Project	IEEE 802.20 Working Group on Mobile Broadband Wireless Acce < <u>http://grouper.ieee.org/groups/802/20/</u> > Simulation Data for Letter Ballot Comments on Quasi-Guard Subcarriers and Reverse Link Waveform 2007-1-17 (Jan 17, 2007) ed	
Title		
Date Submitted		
Source(s):	Anna Tee Samsung Telecommunications America	Voice: 1 (972) 761-7437 Email: <u>atee@sta.samsung.com</u>
Re:	802.20 Letter Ballot Comments	
Abstract	This contribution provides some simulation data for letter ballot comments for 802.20, regarding the issues of quasi-guard subcarriers and reverse link waveform.	
Purpose	To show the benefits for the changes proposed in the original ballot comments.	
Notice	This document has been prepared to assist the IEEE 802.20 Working Group. It is offer as a basis for discussion and is not binding on the contributing individual(s) or organization(s). The material in this document is subject to change in form and content after further study. The contributor(s) reserve(s) the right to add, amend or withdraw material contained herein.

Simulation Data for Letter Ballot Comments on Quasi-guard Subcarriers and Reverse Link Waveform

Lai King (Anna) Tee January 15, 2007

- for different numbers of Quasi-Guard subcarriers

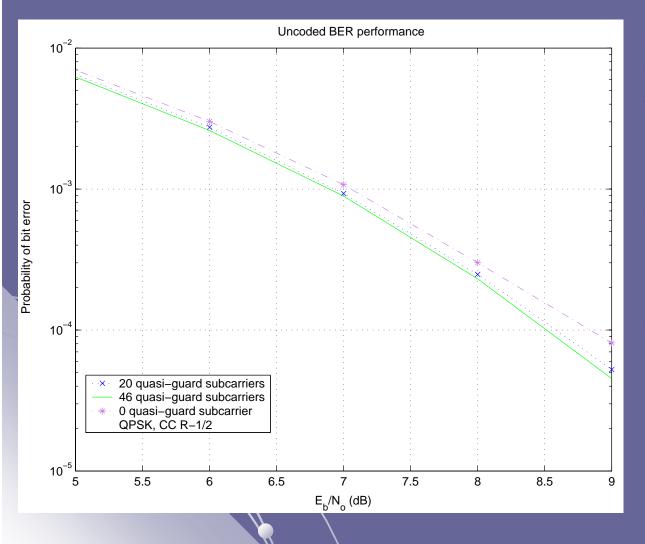
- QPSK, uncoded
- No PA nonlinearity
 - Comparison between:
 - 0, 20 and 46 guard sub-carriers between 2 sub-bands
 - Decrease in data throughput as number of guard sub-carriers increases
- Un-coded BER performance improves as number of quasi-guard sub-carriers increases:
 - ~0.3 dB at 10⁻³ BER, in case of 46 quasiguard sub-carriers

- Insignificant difference between 20 and 46 quasiguard subcarriers
 - 20 quasi-guard subcarriers is an optimal number in this case
- Shows that the optimal number of quasi-guard subcarriers can be very different from that for the normal guard subcarriers at the band edge

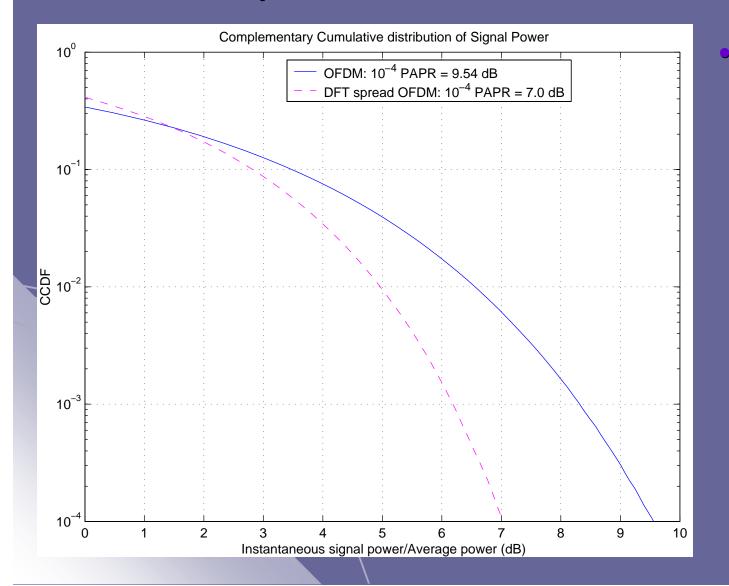
Simulation results also show the implication on tradeoff between channel spacing and performance degradation due to Adjacent Channel Interference

- An important system aspect when multiple carriers are deployed in a given channel block
- Information should be provided for evaluation in accordance with Section 15 of the Evaluation Criteria Document

PAPR Comparison: OFDM vs DFT spread OFDM waveform

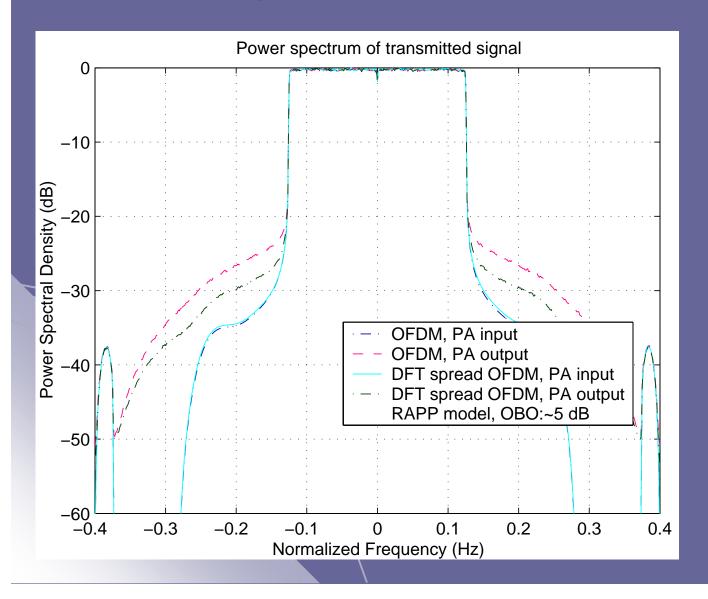
DFT spread OFDM outperforms OFDM waveform by 2.54 dB at 10⁻⁴ CCDF PAPR
